***Kenosha Historic Preservation Commission
Agenda***

Certificate of Appropriateness for Alexander B. McCall House at 6334 Third Avenue, Third Avenue Historic District. (District #2) PUBLIC HEARING

Review of proposed window replacement.

Interior Photos

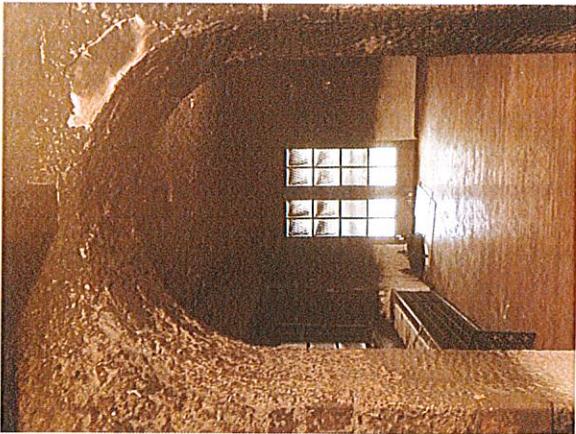
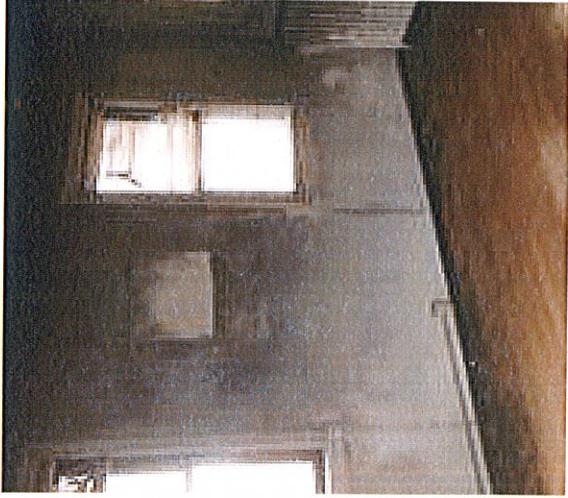
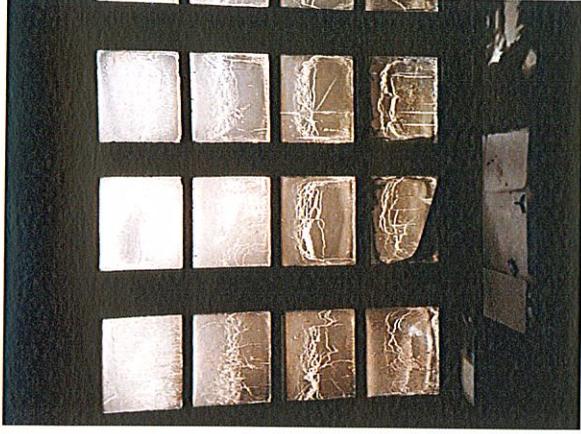
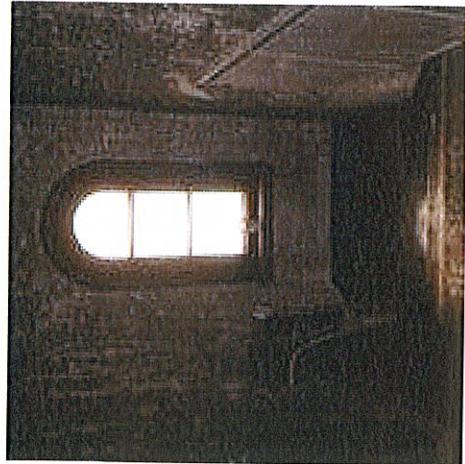
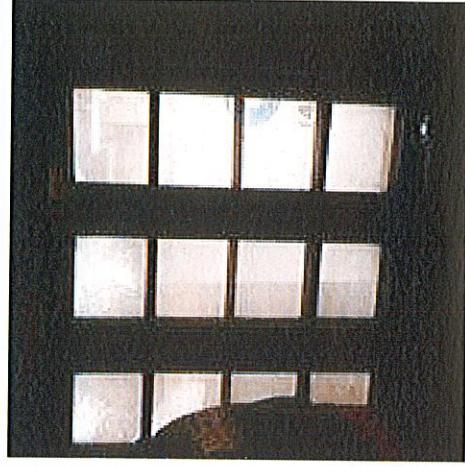
- The home is complimented with arched windows, a red-tiled roof and a cast stone surround on the main entrance portal. Originally, the home had grid patterns in most windows, but some of these have already been replaced over the years. The arched windows also had a diamond pattern glass, some of which have also been replaced.

- The home recently had a fire and has extensive smoke damage throughout the structure. As a part of the rehabilitation, the owner is proposing to replace thirty-eight (38) individual or groupings of windows located on all elevations. The tile roof and all other exterior elements will not be altered.

- The windows currently are a combination of existing windows and replacement windows, including modern aluminum storm windows. There are also nine (9) arched windows located on the south, east and north elevations that retain a colored diamond pattern glass. These windows are also proposed to be replaced and require a Certificate of Appropriateness from the Historic Preservation Commission.

- The proposed windows replicate the existing sizes and appearance of the existing remaining windows, including window grids. There will be some change to the appearance of the windows since the existing wooden and aluminum storm windows will also be replaced.

A recommendation is made to approve the Certificate of Appropriateness in conformance with Standard 10 of Section 15.10 D. of the Zoning Ordinance for the City of Kenosha, with a recommendation to retain the remaining nine (9) arched windows with the diamond pattern glass.
